Plan Commission

AGENDA

VILLAGE OF
McFarland
SUMMARY SHEET

The Applicant (Kwik Trip, Inc.) is requesting a conditional use permit to build a gas station and convenience store, including accessory carwash, outdoor merchandising of products, and general fleet/truck parking, at 4015 Terminal Drive. Kwik Trip is also seeking approval of an associated site design permit. The November 15 Plan Commission meeting includes a public hearing on the conditional use permit and action on the conditional use permit and site design permit are anticipated for the December 20 Plan Commission meeting. The following staff report includes comments regarding both the conditional use permit and the site design permit as the design of the site and building are integral to the conditional use permit review and any conditions and guarantees the Plan Commission may deem appropriate per Sec. 62-114.

DRAWN BY	S. ANDERSON / M. WAHL
SCALE	NOTED
PROJ. NO.	121.0883.30
DATE	OCTOBER 4, 2021
SHEET	SP 1.1

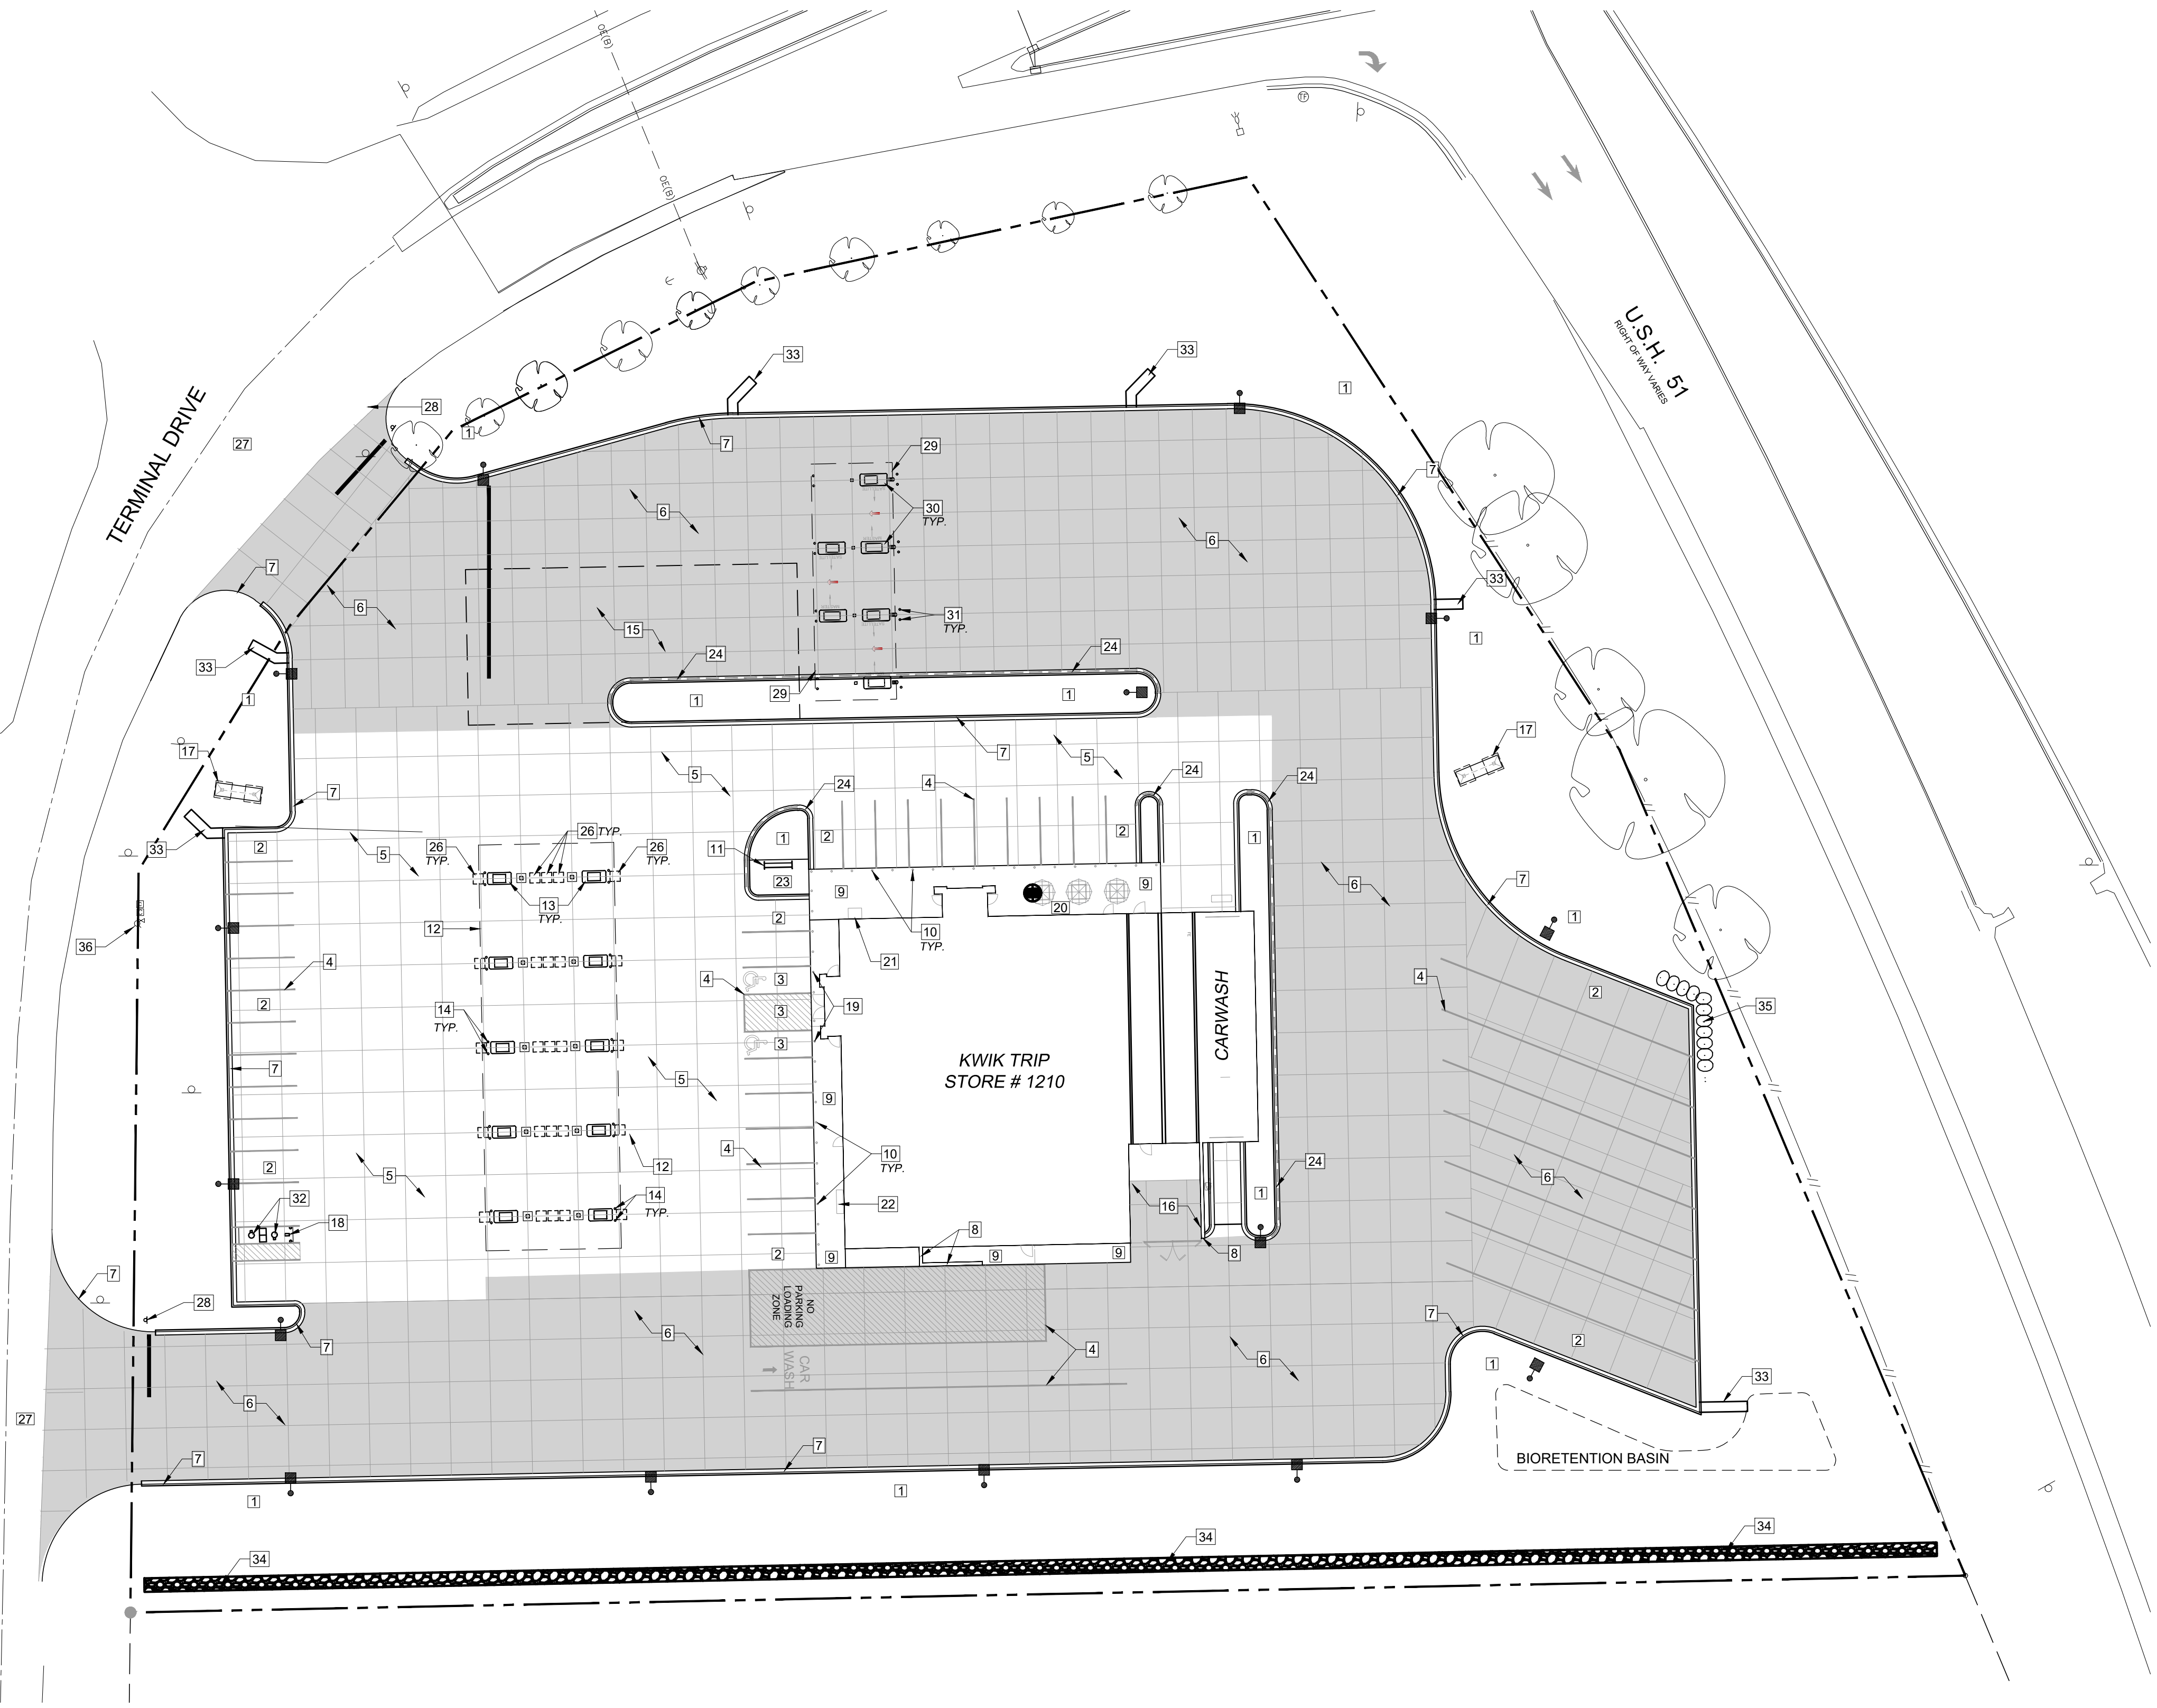
Sheet SP 1.1 – Past discussion and concept plans for this area envision curb and sidewalk for Terminal Drive. This is also the case for the upcoming Village project for the 2022 project on the south end of Terminal Drive. We recommend including sidewalk and curb and gutter along the Terminal Drive frontage of this site as part of the Kwik Trip project.

DRAWN BY	S. ANDERSON / M. WAHL
SCALE	NOTED
PROJ. NO.	121.0883.30
DATE	OCTOBER 4, 2021
SHEET	SP 2.0

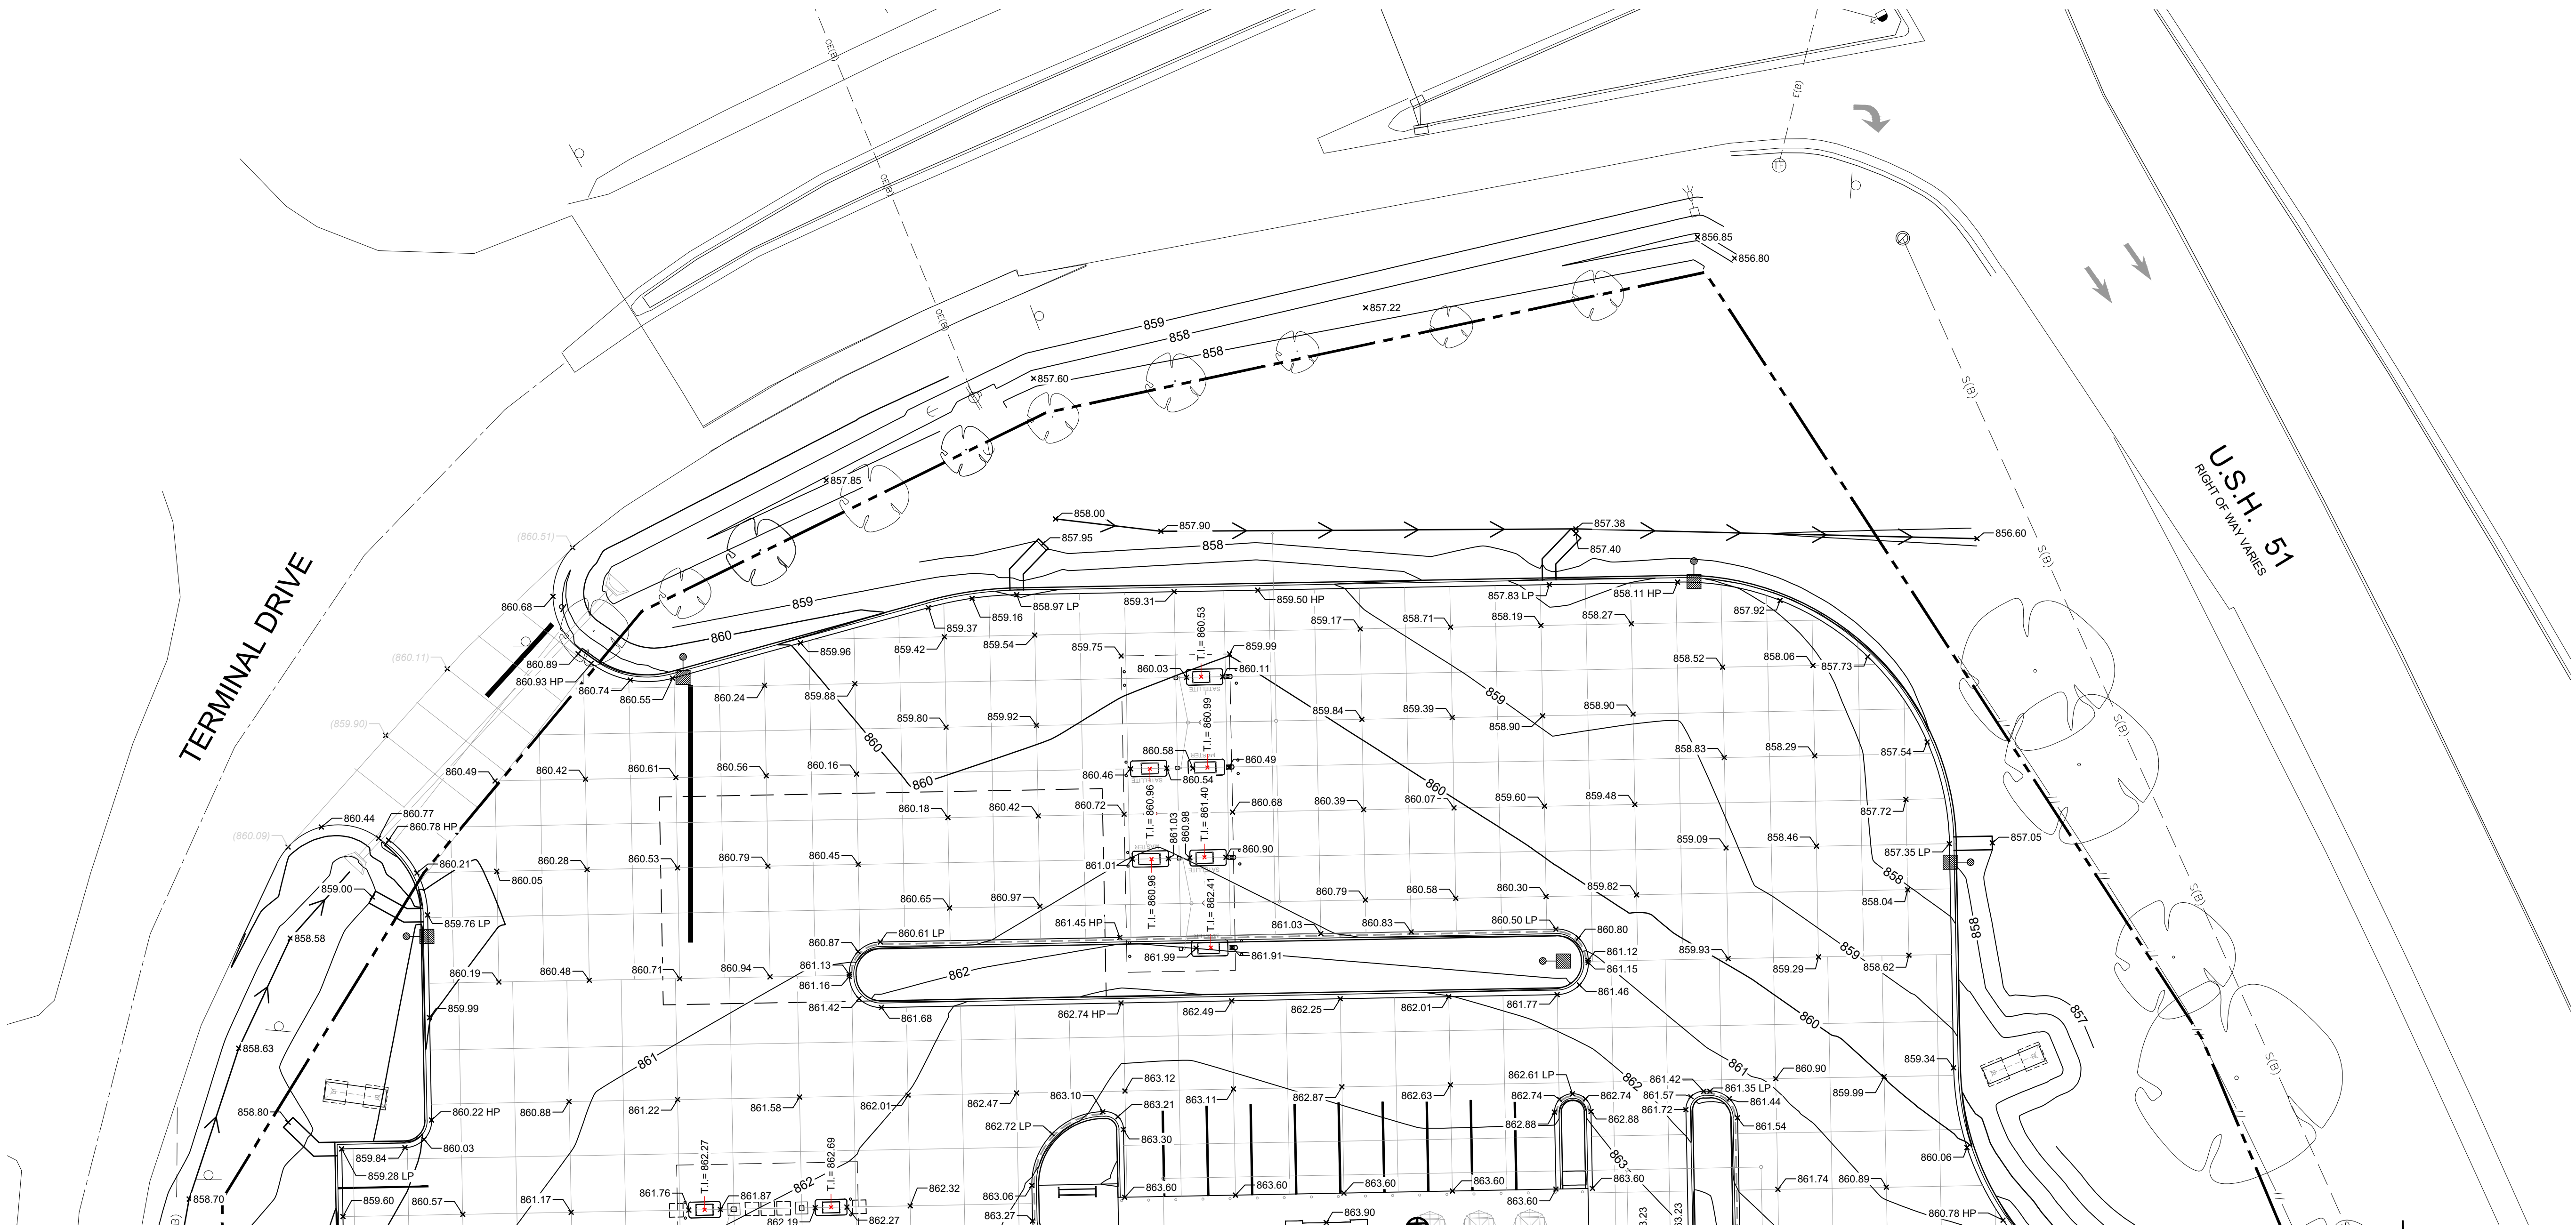
Sheet SP 2.0 – There are several storm sewer discharge points on to USH 51 right-of-way. DOT usually requires review and approval for these. Approval (or confirmation that none is needed) should be provided.

DRAWN BY	S. ANDERSON / M. WAHL
SCALE	NOTED
PROJ. NO.	121.0883.30
DATE	OCTOBER 4, 2021
SHEET	SP 3.1

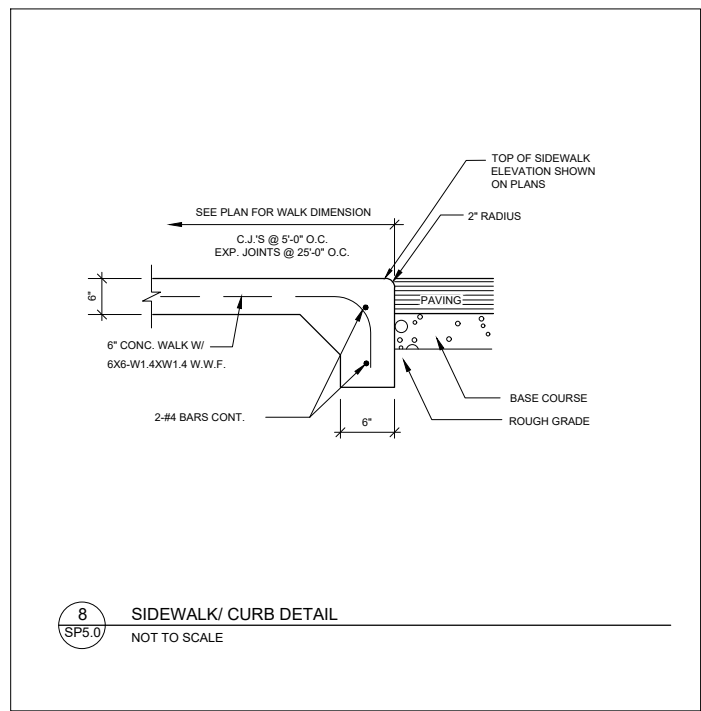
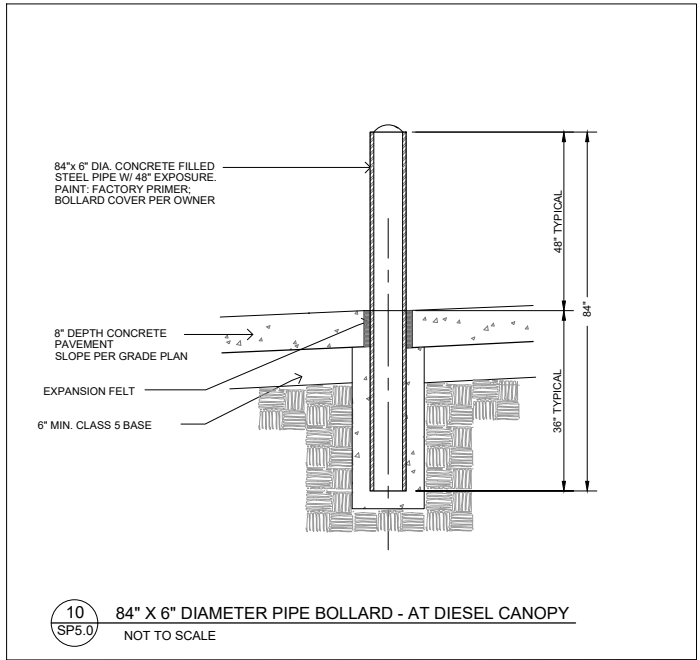
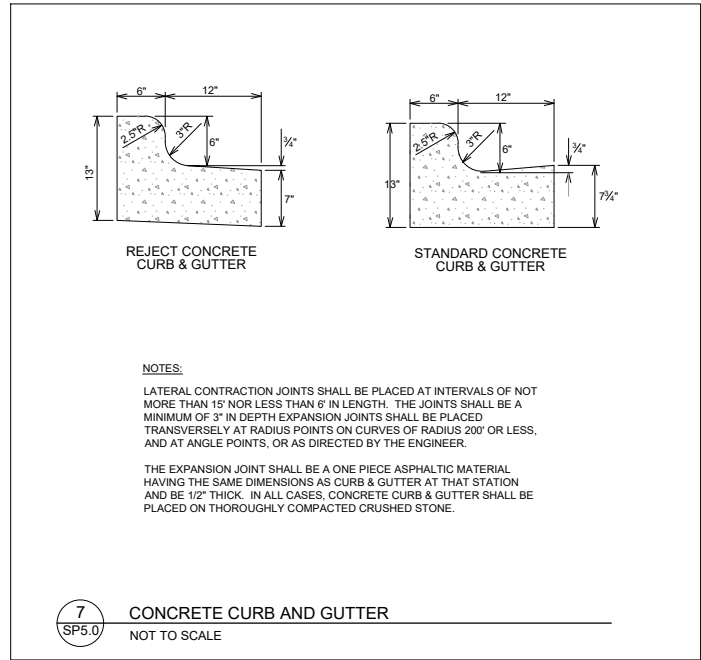
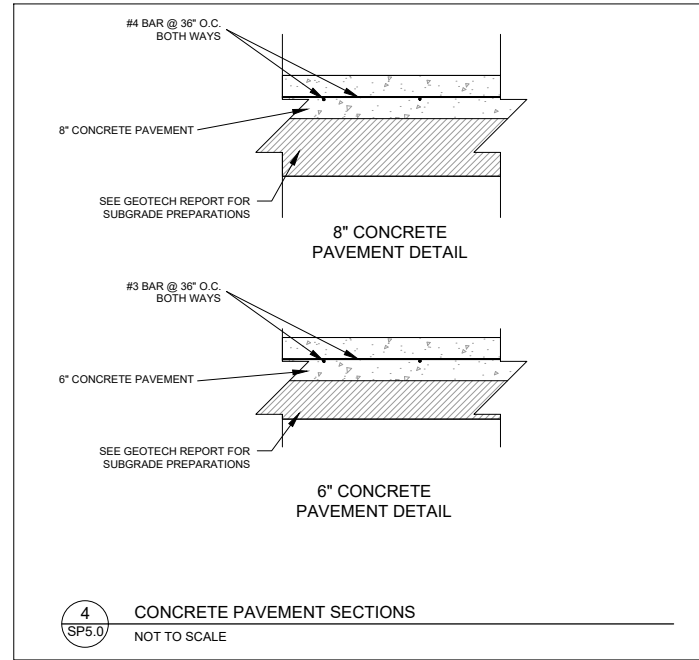
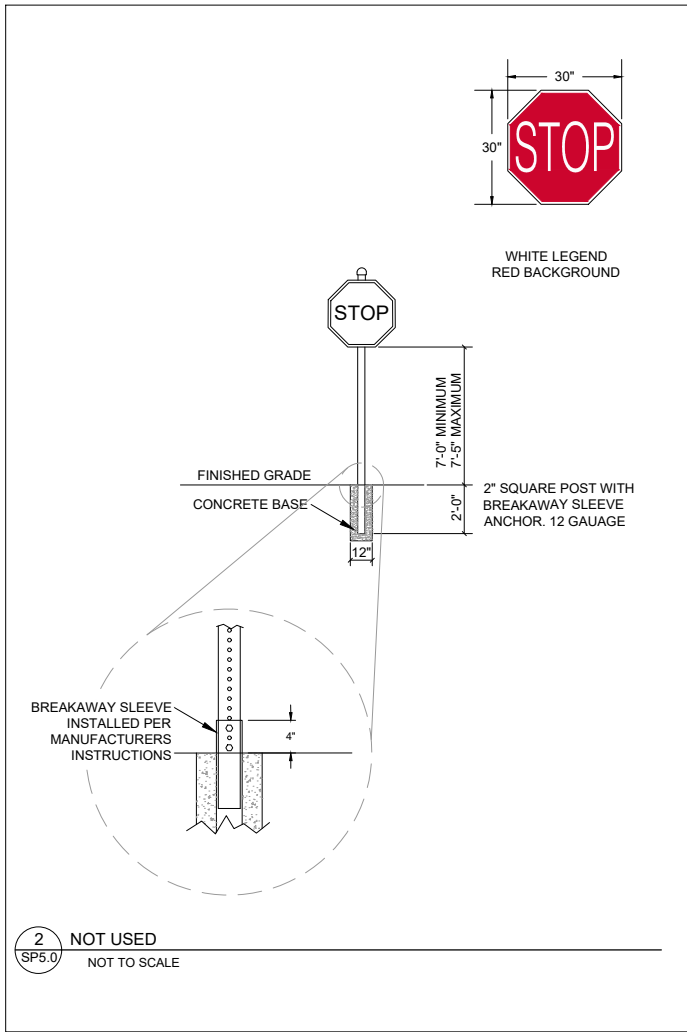
Sheet SP 3.1 – The existing water service will be re-used, and extended. The fire chief should confirm the location/count of internal hydrants is sufficient.
